Subject: Issuance of Amendment No. 1 to Facility Operating  
License NPF-29 Grand Gulf Nuclear Station, Unit No. 1

AMENDMENT TO FACILITY OPERATING LICENSE

Amendment No. 1  
License No. NPF-29

SAFETY EVALUATION BY THE OFFICE OF NUCLEAR REACTOR REGULATION  
RELATED TO AMENDMENT NO. 1 TO FACILITY OPERATING LICENSE NPF-29

FIGURE 6.2.1-1 OFFSITE ORGANIZATION

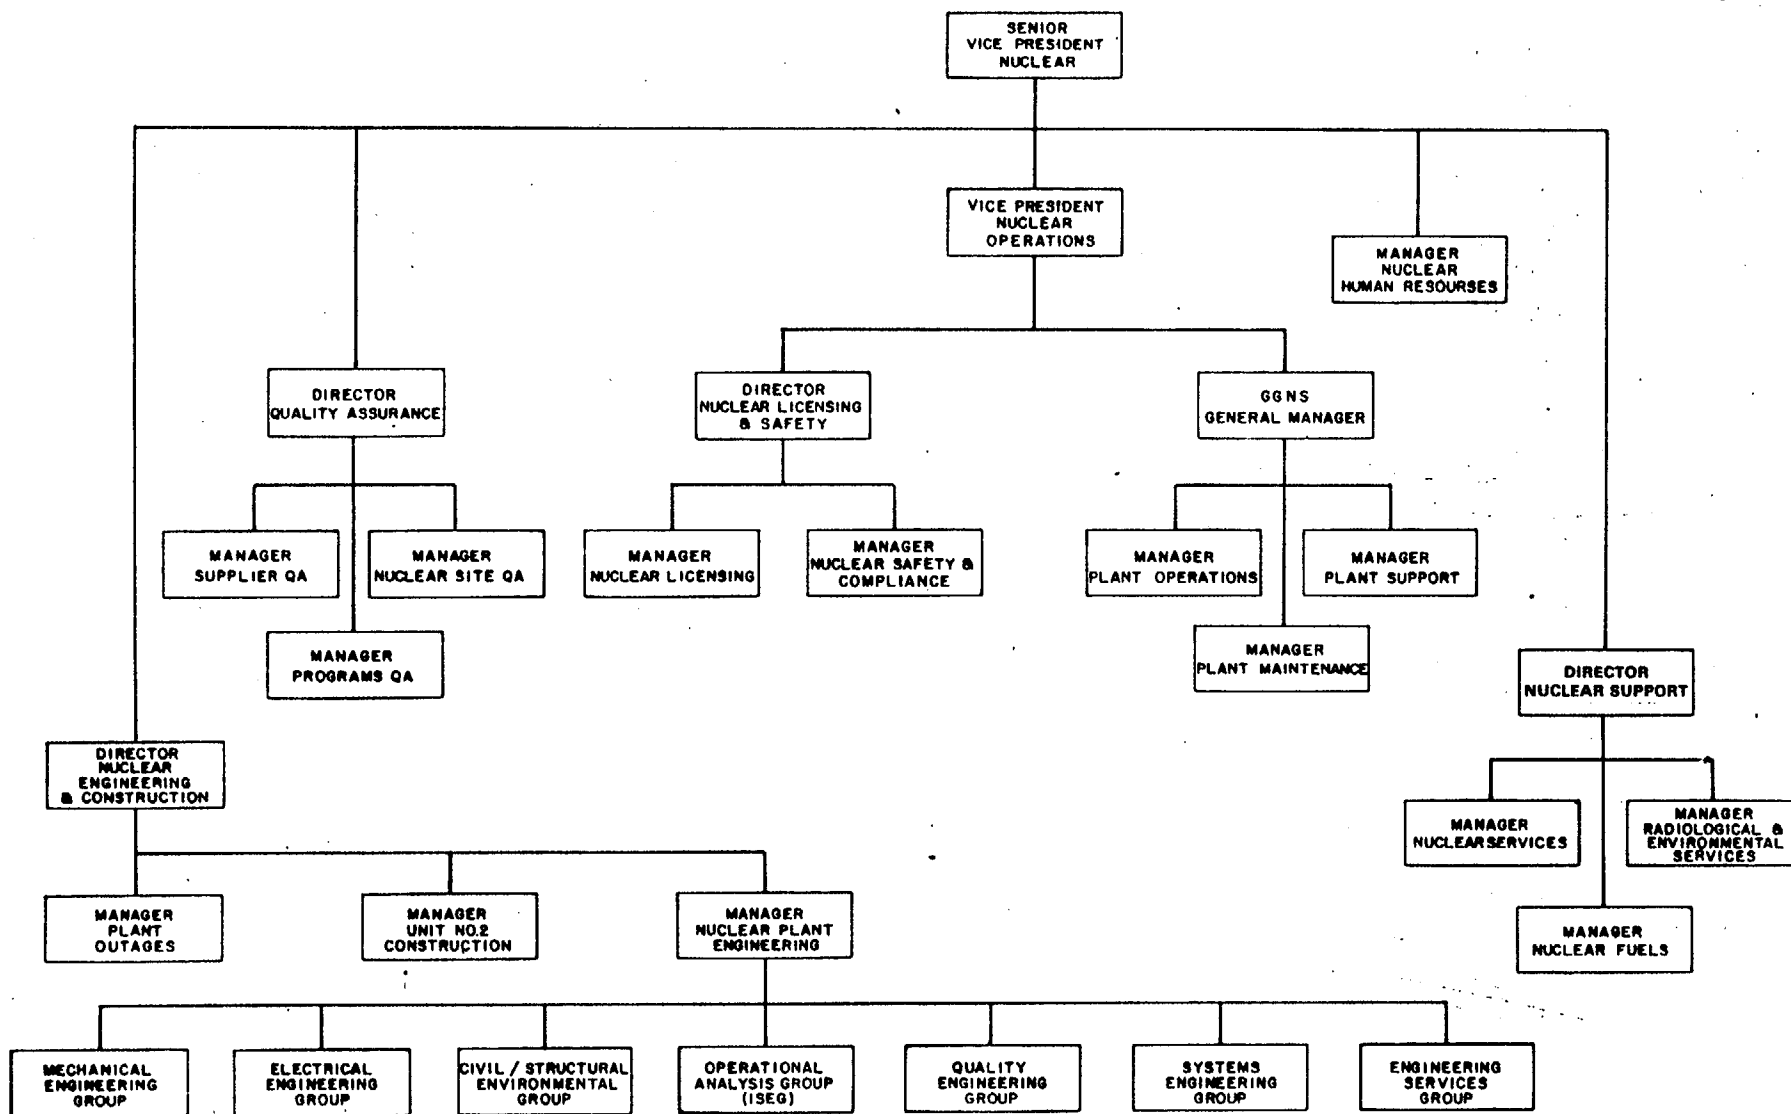
The proposed amendment would revise Figure 6.2.1-1 "Offsite Organization" in the Technical Specifications by changing a position title from "Vice President - Nuclear Support" to "Director - Nuclear Support". The person occupying this position is responsible for nuclear fuel, offsite nuclear service and support, and radiological and environmental matters including radiochemistry service and support. The person in this position reports to the Senior Vice President - Nuclear. The change would not affect the responsibilities or reporting requirements of this position, but would be a change in title only. The licensee requested the change because the responsibilities and qualifications of this position are equivalent to those of other directors in the department rather than those of vice presidents.

The staff has reviewed the proposed change and concludes that it is acceptable because it is a change in position title only.
